TELEDYNE CONTINENTAL[®] AIRCRAFT ENGINE
SERVICE INFORMATION LETTER

Category 5
SIL05-6A

SUBJECT: IO-240-B SERIES PRODUCT UPGRADES

PURPOSE: To provide an overview of product upgrades necessary to upgrade IO-240-series engines to current production configuration.

FIGURE 1
P/N 656143-1 FUEL PUMP INLET FILTER INSTALLATION

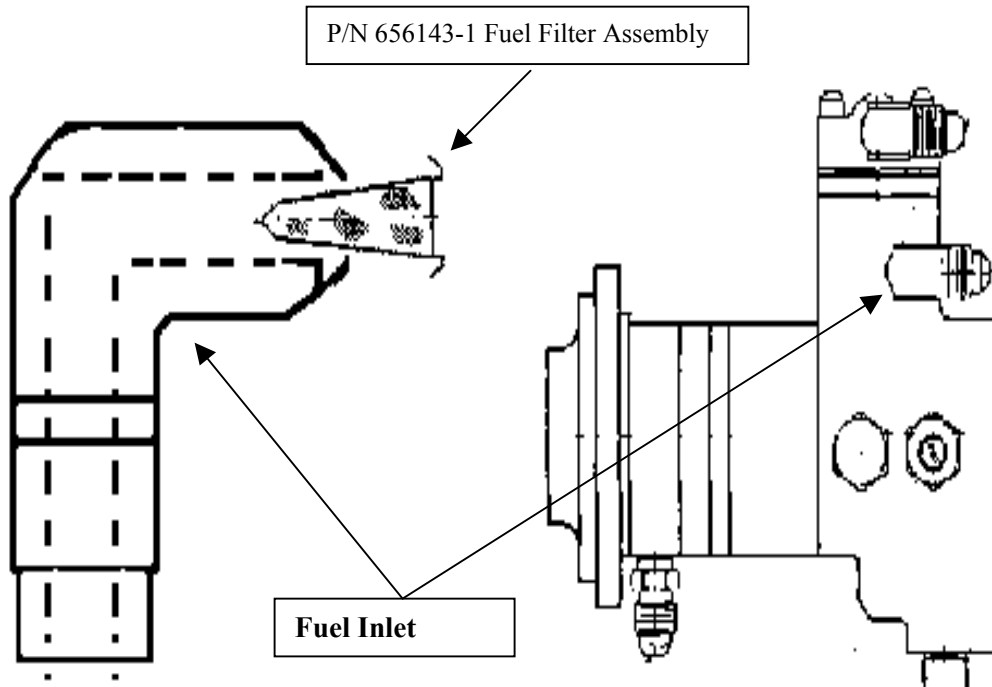
In order to enhance the aircraft fuel filtration system, DIAMOND AIRCRAFT has requested the optional installation of an additional fuel line filter screen at the engine driven fuel pump inlet fitting. Installation of the fuel pump inlet filter is recommended by Teledyne Continental Motors. Screen P/N 656143-1 is available from Diamond Aircraft or a TCM Authorized Distributor.

- (g) Insert the P/N 656143-1 fuel filter element into the fuel inlet fitting. Ensure that the fuel filter flange seats against the fitting flare. Reference Figure 1.

- (i) Remove the protective cover from the fuel pump inlet fitting and insert the P/N 656143-1 fuel filter element into the fuel inlet fitting. Ensure that the fuel filter flange seats against the fitting flare. (Reference Figure 1.)

NOTE: The P/N 656143-1 fuel pump inlet filter is to be installed in addition to the P/N 656859 Inline Fuel Filter Installation, reference SIL05-4.
